**Alliance** OF AUTOMOBILE MANUFACTURERS

**Re.: Occupant Crash Protection Final Rule; 49 CFR Parts 552, 571, 585, and 595  
Docket No. NHTSA-00-7013; (65 Fed. Reg. 30680; May 12, 2000)**

## **ATTACHMENT A – Petition for Reconsideration**

FIGURE A-1: Illustration of unrepresentative and unnatural position of 5<sup>th</sup> percentile female dummy knee when dummy's foot is positioned according to S16.3.2.3.4 in vehicles with seat with relatively low H-points.

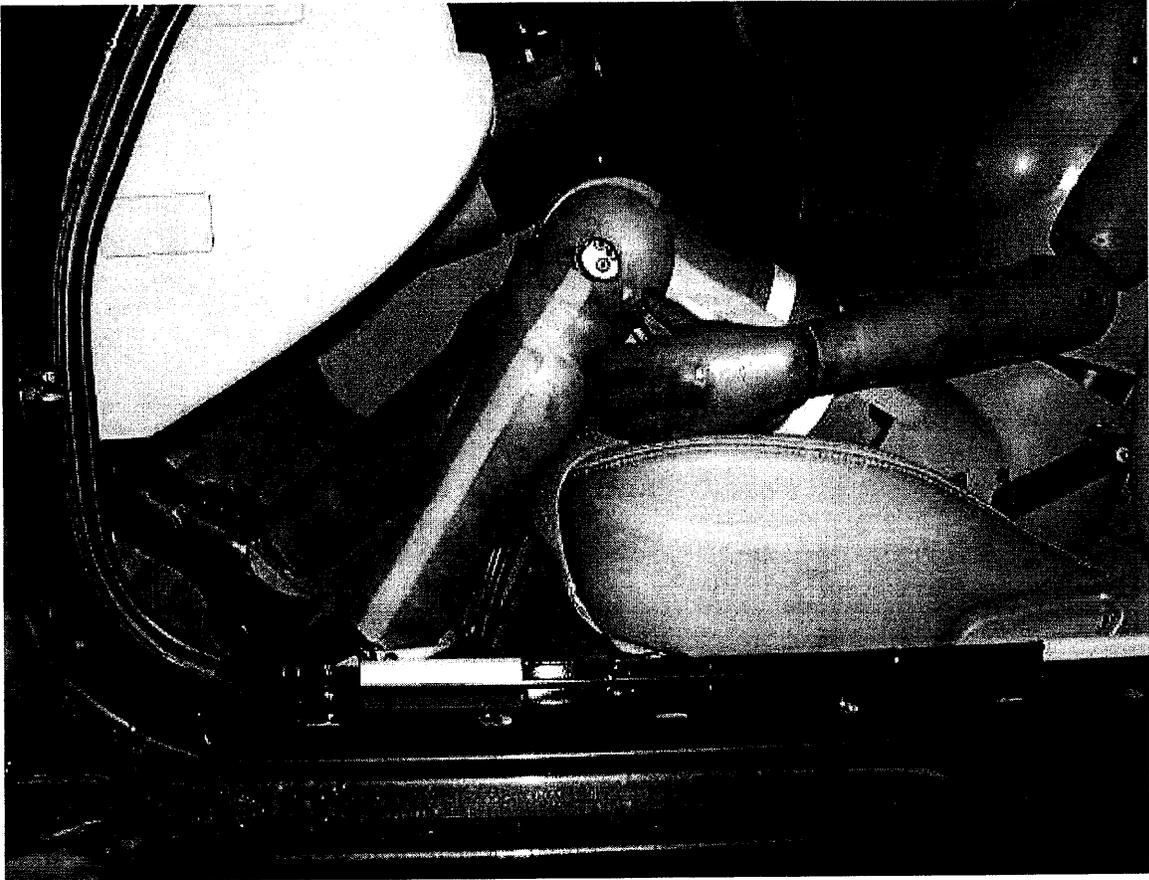
Section 16.3.2.3.4 of the final rule requires the left foot of the 5th percentile female dummy, when in the driver's position, to be placed flat on the floor if the foot does not reach the toeboard. This section further requires that the foot be placed as far forward as possible. In some vehicles placing the foot flat on the floor is impracticable, due to the limited rotation of the joint attaching the foot to the lower limb. In vehicles with seats having a low H-point relative to the vehicle floor pan the foot must be slid rearward quite significantly in order to position it flat on the floor. As the foot is slid rearward the knee rises into an unrepresentative and unnatural position (please see Figure A-1).

Likewise, Section 16.3.3.3 also has the same requirement for the dummy feet positioning on the passenger side. This requirement, again, results in the dummy's feet being positioned very far rearward with the knees positioned unrepresentatively and unnaturally high for seats with low H-points relative to the floor pan. The Alliance recommends that in the case that the feet do not reach the toeboard that the feet be placed as far forward as possible and positioned perpendicular to the lower limb as is already required for the 50th percentile male.
